Office Action Summary

10/522,044

DROTT ET AL.

DETAILED ACTION

**FIG. 2**

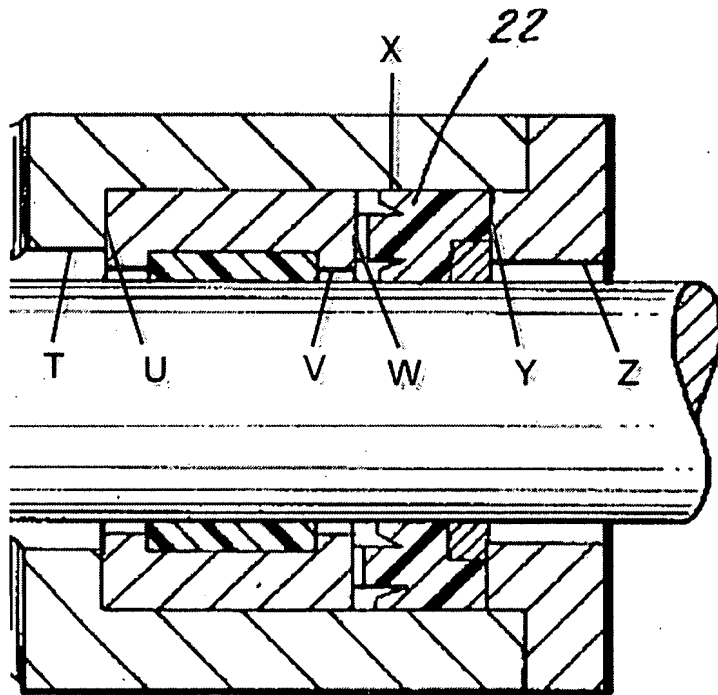
Regarding claim 15, the Zollner reference, as best understood, discloses a cylinder-and-piston unit (Col. 1, Lines 5-15) comprising a cylinder (e.g. including 5, D, and upper element 21 in contact with 22), a piston (6) and a sealing collar (22), the cylinder comprising a bore (e.g. bore of cylinder accommodating piston 6), and the cylinder having a wall surface (e.g. inner most surface of cylinder) along the bore, the wall surface comprising a first sidewall (V) extending parallel to a longitudinal axis of the bore (Fig. 2), a second sidewall (W) contiguous with the first sidewall and extending

generally perpendicularly to the first sidewall (Fig. 2), a third sidewall (X) contiguous with the second sidewall and extending generally parallel to the first sidewall (Fig. 2), a fourth sidewall (Y) contiguous with the third sidewall and extending generally parallel to the second sidewall (Fig. 2), and a fifth sidewall (Z) contiguous with the fourth sidewall and extending generally parallel to the first sidewall along the bore (Fig. 2), the second, third and fourth sidewalls being parts of one unitary body, forming a groove (e.g. groove formed by walls W, X and Y) that is recessed in the wall surface (Fig. 2), the sealing collar being positioned in the groove (Fig. 2) and comprising an outside sealing lip (B) and an inside sealing lip (A), the outside and inside sealing lips each having a free end (i.e. the ends facing downwards in Fig. 2), the sealing collar further including a circumferential extension (C) that extends in parallel to the sealing lips (Fig. 2), being arranged radially between the outside sealing lip and the inside sealing lip and projects axially beyond the free ends of the outside and inside sealing lips (Fig. 2), the circumferential extension being configured to contact the second sidewall in the groove (Fig. 2) and maintain the free ends of the outside and inside sealing lips out of contact with the second sidewall (Fig. 2).

Regarding claim 16, the Zollner reference, as best understood, discloses a cylinder-and-piston unit (Col. 1, Lines 5-15) comprising a cylinder (e.g. including 5, D, and upper element 21 in contact with 22), a piston (6) and a sealing collar (22), the cylinder comprising a bore (e.g. bore of cylinder accommodating piston 6), and the cylinder having a wall surface (e.g. inner most surface of cylinder) along the bore, the wall surface comprising a first sidewall (V) extending parallel to a longitudinal axis of the

bore (Fig. 2), a second sidewall (W) contiguous with the first sidewall and extending generally perpendicularly to the first sidewall (Fig. 2), a third sidewall (X) contiguous with the second sidewall and extending generally parallel to the first sidewall (Fig. 2), a fourth sidewall (Y) contiguous with the third sidewall and extending generally parallel to the second sidewall (Fig. 2), and a fifth sidewall (Z) contiguous with the fourth sidewall and extending generally parallel to the first sidewall along the bore (Fig. 2), the second, third and fourth sidewalls being parts of one unitary body and forming a groove (e.g. groove formed by walls W, X and Z) that is recessed in the wall surface (Fig. 2), the sealing collar being positioned in the groove (Fig. 2) and comprising a first sealing lip (A) and a second sealing lip (B), the first sealing lip being acted upon dynamically and making contact with the piston (Fig. 2) and the second sealing lip thereof being acted upon statically while resting on a bottom of the groove (Fig. 2), the first and second sealing lips each having a free end (i.e. the ends facing downwards in Fig. 2), the sealing collar further including a circumferential extension (C) that extends between the first and second sealing lips (Fig. 2), and projects from the first and second sealing lips in an axial direction beyond the free ends of the first and second sealing lips (Fig. 2), the sealing collar having a rear surface (e.g. surface of element 22 in contact with element D) opposite the free ends of the first and second sealing lips, wherein the sealing collar has a maximum radial width at the free end of the second sealing lip and a minimum radial width at the rear surface (Fig. 2). Note that the radial width at the rear surface will always be smaller than the maximum width because of supporting ring 1.

Regarding claim 17, the Zollner reference discloses the axial width of the groove being larger than the axial width of the sealing collar (Fig. 2). Note that the axial width of the groove of the Zollner reference is larger than the axial width of the sealing collar at different cross sections.

Regarding claim 18, the Zollner reference discloses the second sealing lip (B). Note that the second lip of the Zollner reference is capable of being passed over by pressure fluid flow and hence provide the effect of a valve, because the structure as claimed in claim 16 is the same as the structure of the Zollner reference.

Regarding claim 19, the Zollner reference discloses the strength of the extension as a difference between its inside and outside diameters has at least the same rate as the strength of each of the sealing lips. Note that the seal of the Zollner reference is made of one material and since the extension has a thicker diameter, it will have a strength that is equal, if not greater, than the strength of the lips.

Regarding claim 20, the Zollner reference discloses the extension being provided with radial apertures (F). Note that the apertures are capable of allowing pressure fluid to pass through in a radial direction.

Regarding claim 22, the Zollner reference discloses the apertures being open in an axial direction towards the free end of the extension (Fig. 2).

Regarding claim 23, the Zollner reference discloses the extension being integrally connected to the sealing collar and being made of the same material (Fig. 2).

contact with 22), a piston (6) and a sealing collar (22), the cylinder comprising a bore (e.g. bore of cylinder accommodating piston 6), and the cylinder having a wall surface (e.g. inner most surface of cylinder) along the bore, the wall surface comprising a first sidewall (V) extending parallel to a longitudinal axis of the bore (Fig. 2), a second sidewall (W) contiguous with the first sidewall and extending generally perpendicularly to the first sidewall (Fig. 2), a third sidewall (X) contiguous with the second sidewall and extending generally parallel to the first sidewall (Fig. 2), a fourth sidewall (Y) contiguous with the third sidewall and extending generally parallel to the second sidewall (Fig. 2), and a fifth sidewall (Z) contiguous with the fourth sidewall and extending generally parallel to the first sidewall along the bore (Fig. 2), the second, third and fourth sidewalls being parts of one unitary body and bordering a groove that is recessed in the wall surface (Fig. 2), the sealing collar being positioned in the groove and comprising an outside sealing lip (B) and an inside sealing lip (A), the outside and inside sealing lips each having a free end (i.e. the ends facing downwards in Fig. 2), the sealing collar further including a circumferential extension (C) that extends in parallel to the sealing lips (Fig. 2), is arranged radially between the outside sealing lip and the inside sealing lip and has a free end that projects axially beyond the free ends of the outside and inside sealing lips (Fig. 2), the circumferential extension engaging the second sidewall of the groove (Fig. 2) and maintaining the free ends of the outside and inside sealing lips out of contact with the second sidewall (Fig. 2).

Regarding claim 25, the Zollner reference discloses the free end of the circumferential extension being provided with radial apertures (F). Note that the apertures are **capable of** allowing pressure fluid to pass through in a radial direction.

Regarding claim 26, the Zollner reference discloses the sealing collar having a rear surface (e.g. surface of element 22 in contact with element 1 that is parallel to the surface of element C in contact with element 21) opposite the free ends of the outside and inside sealing lips, wherein the sealing collar has a maximum outside diameter at the free end of the outside sealing lip and a minimum outside diameter at the rear surface (Fig. 2). Note the minimum outside diameter is the same width as the supporting ring 1 and will always be smaller than the maximum diameter at the outside seal.
